**Subject: Change Order No. 5 Water Treatment Plant
Improvements Phase 2 Project**

Re: City of Junction City
Water Treatment Plant Improvements Phase 2
KPWSLF Project Number 3046
HDR Project #10132258 / 10308785
Change Order No. 5 Transmittal

Water Treatment Plant Improvements-
Phase 2

Change Order No. 5

SHEET
00Y002

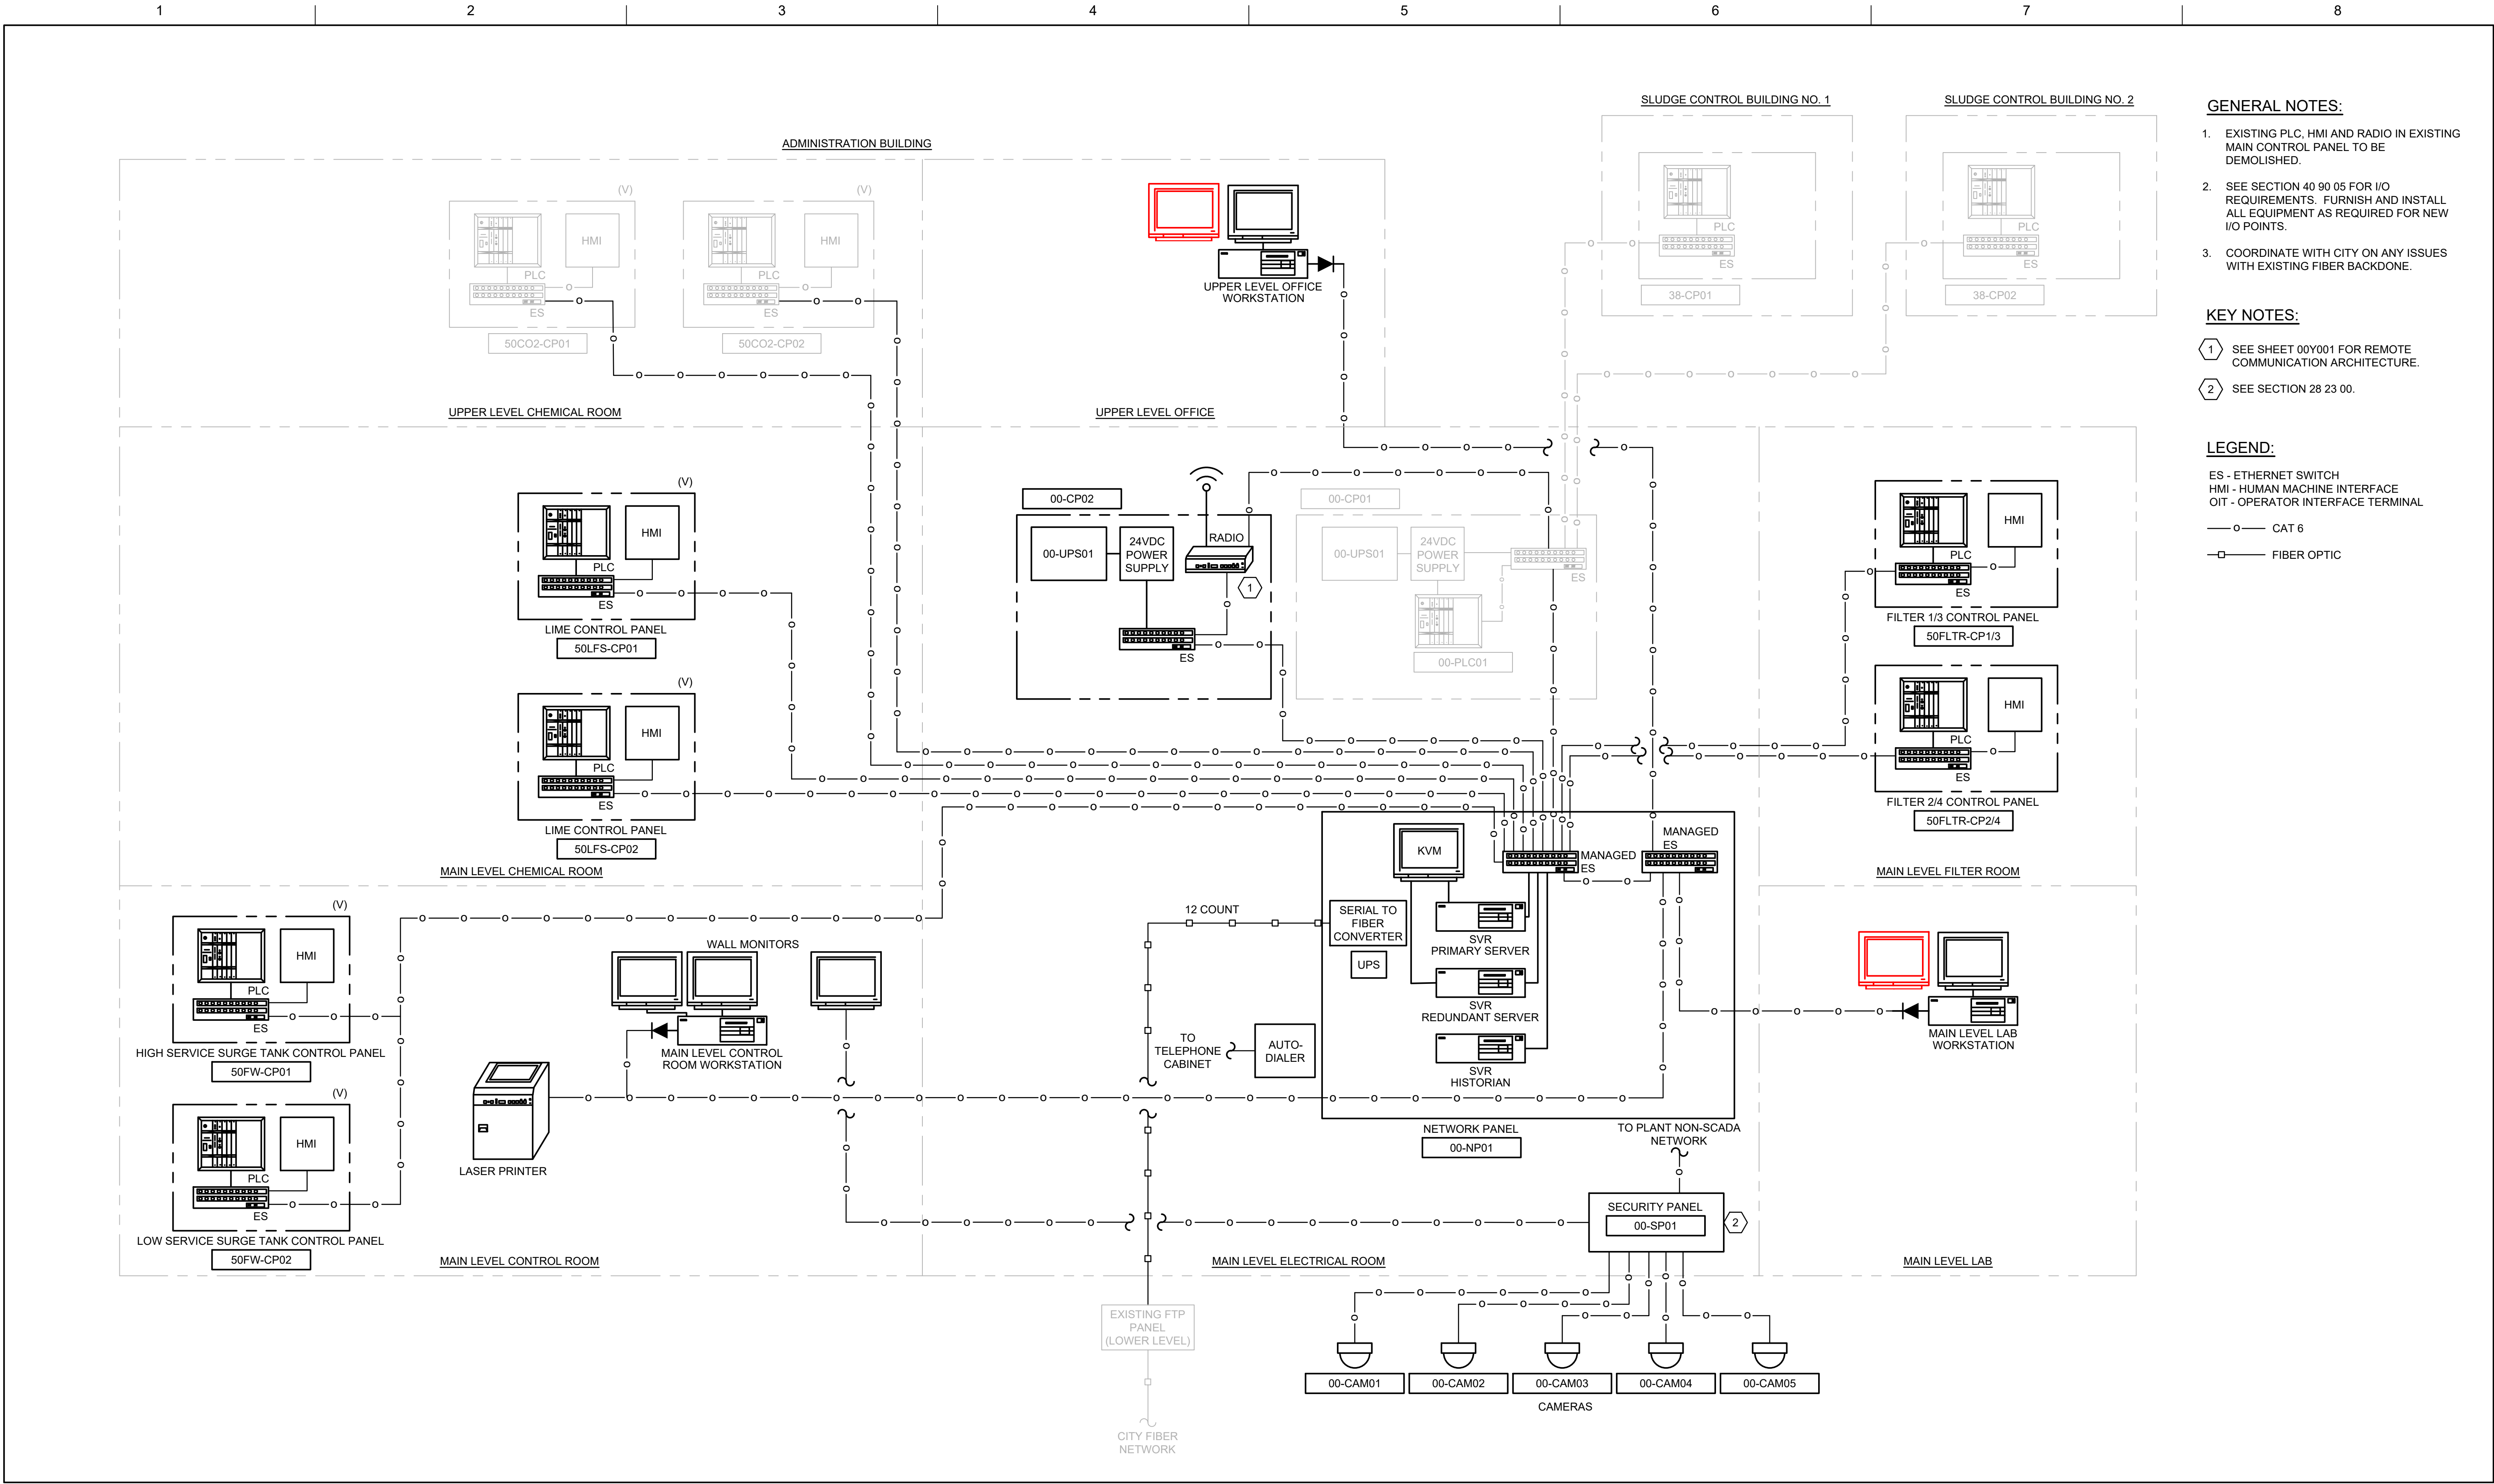
Add one additional monitor at the upstairs workstation and one additional monitor at the lab workstation.

ADMINISTRATION AND PROCESS BUILDING
OFFICE AND CHEMICAL AREA
ELECTRICAL PLAN EL 1085.00

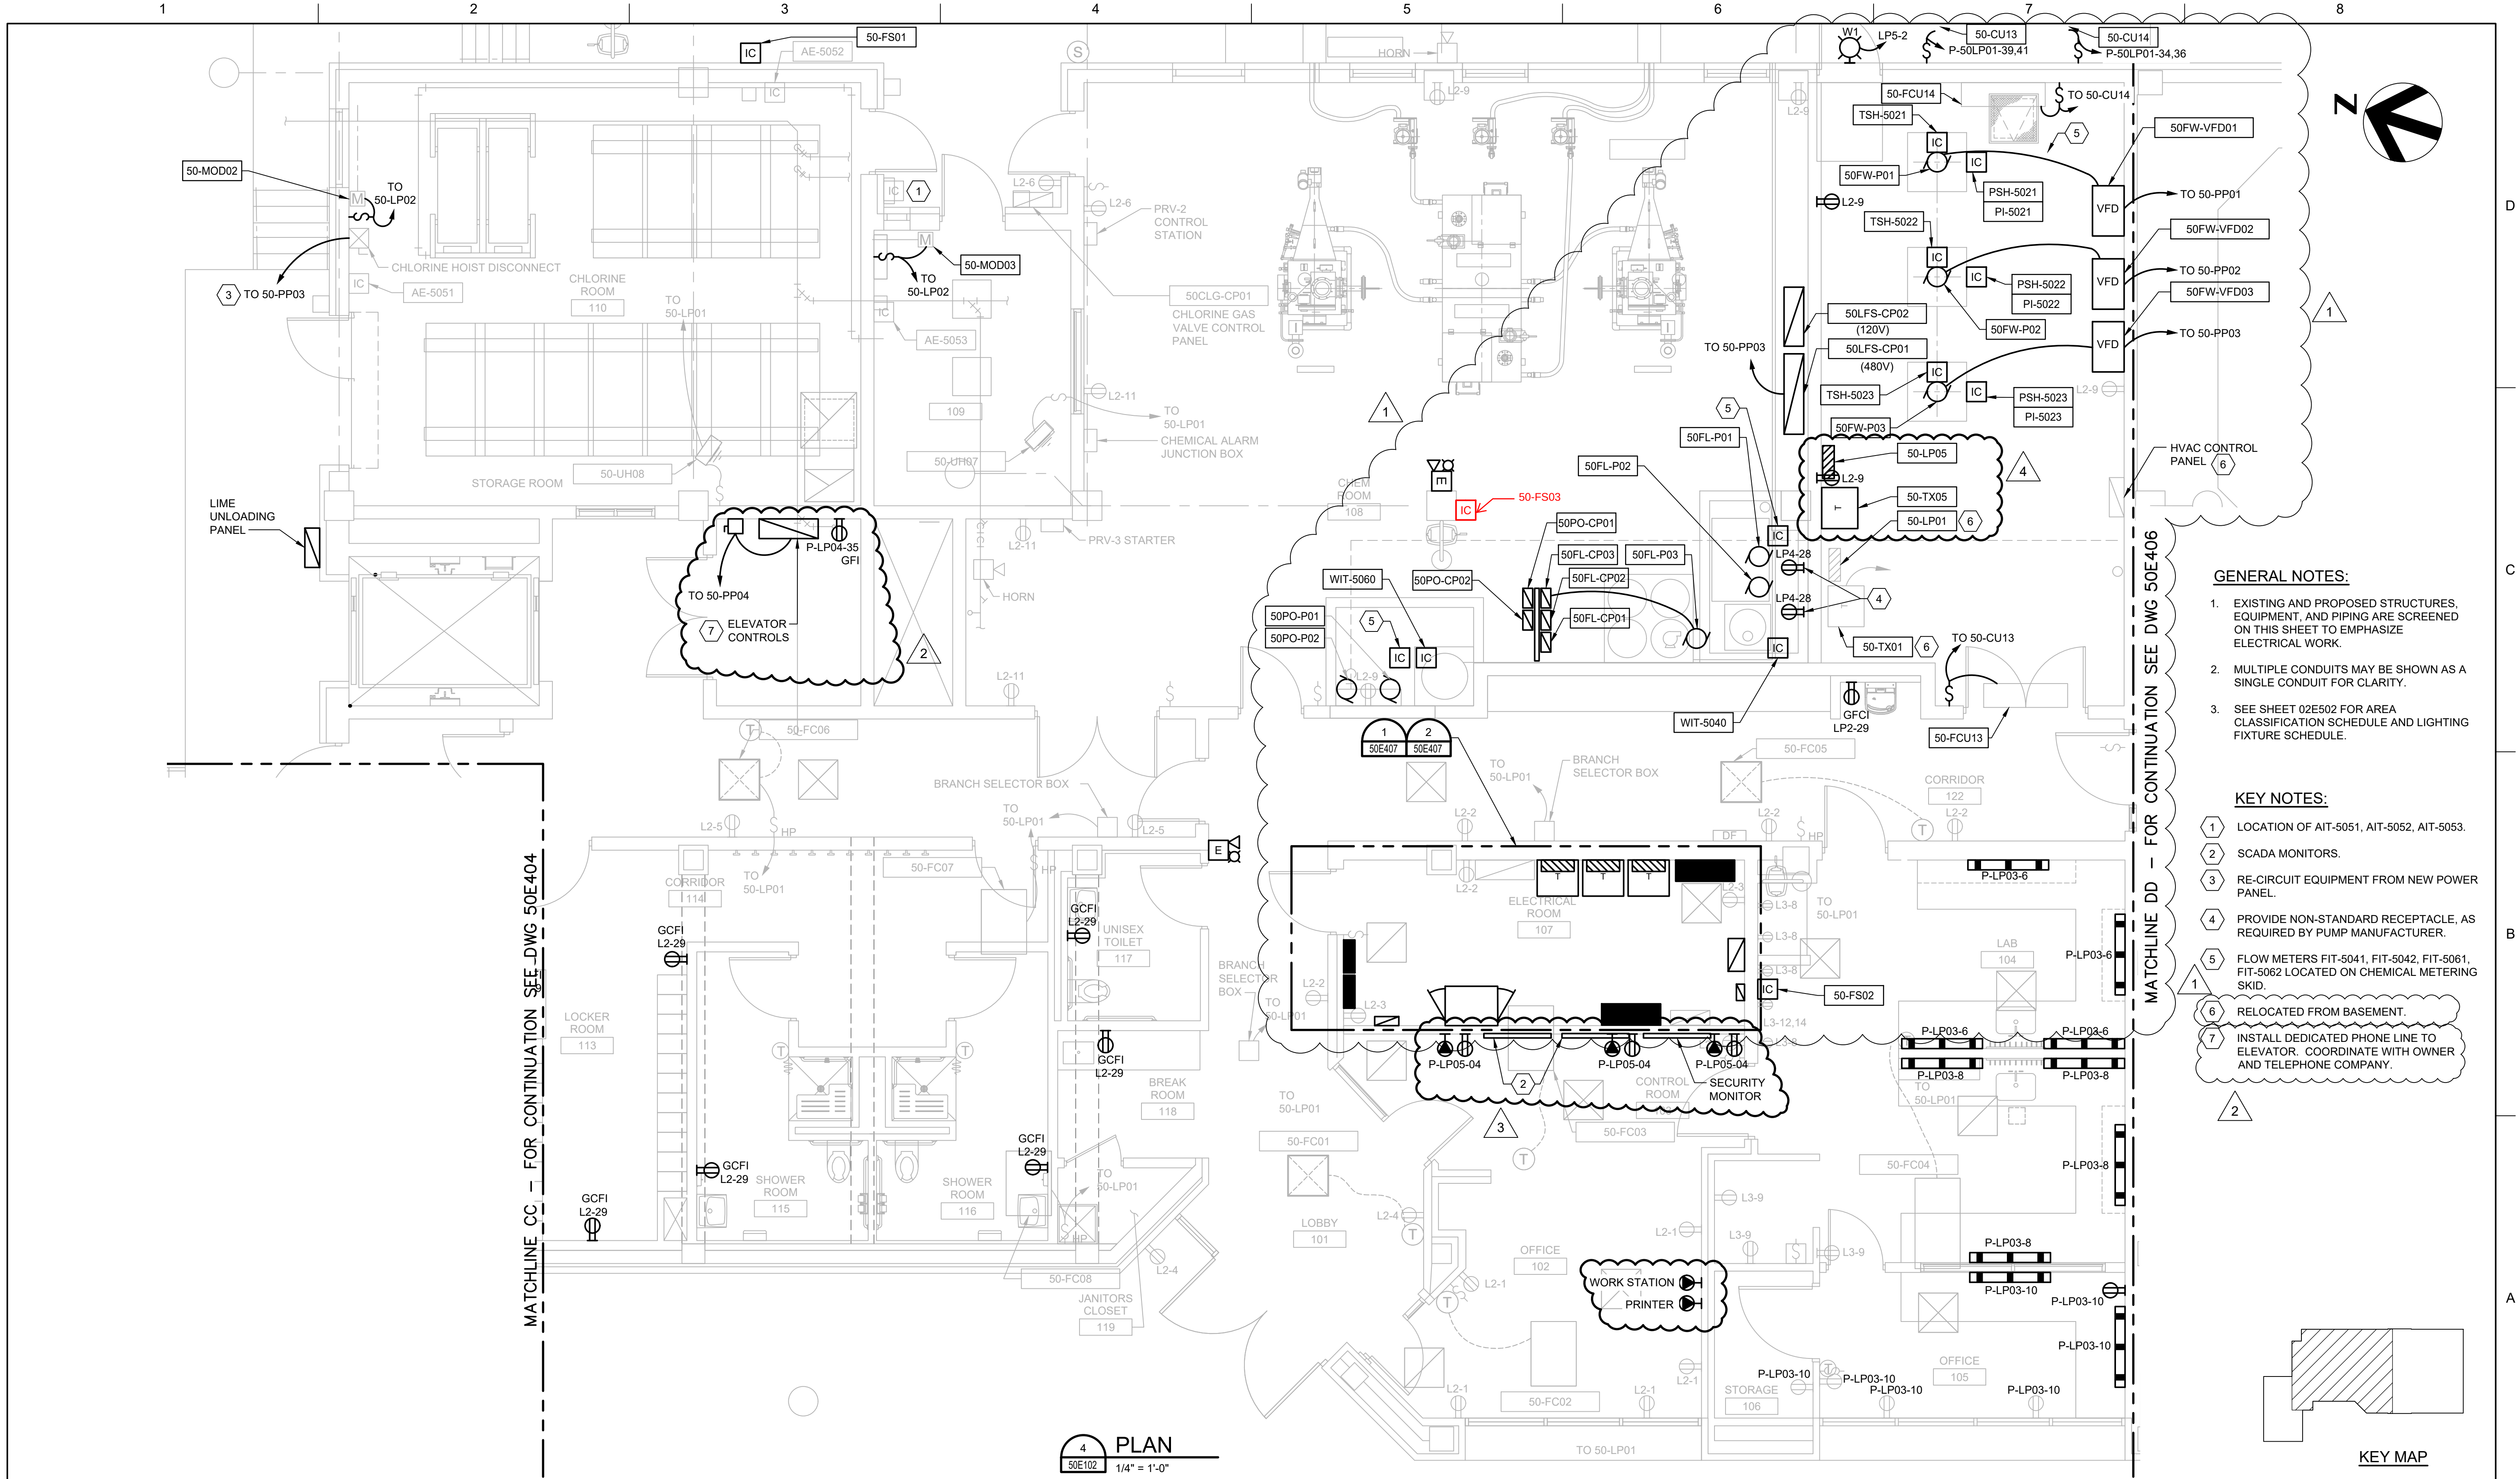
- **Work Change Directive (WCD) #50 – Float/ Emergency Alarm**
This WCD provides for work required to install a dedicated high-water alarm in the sub-basement of the treatment plant. The value of this WCD is an increase in Contract Price of \$2,216.00. There is no change in the Contract Time associated with this WCD.
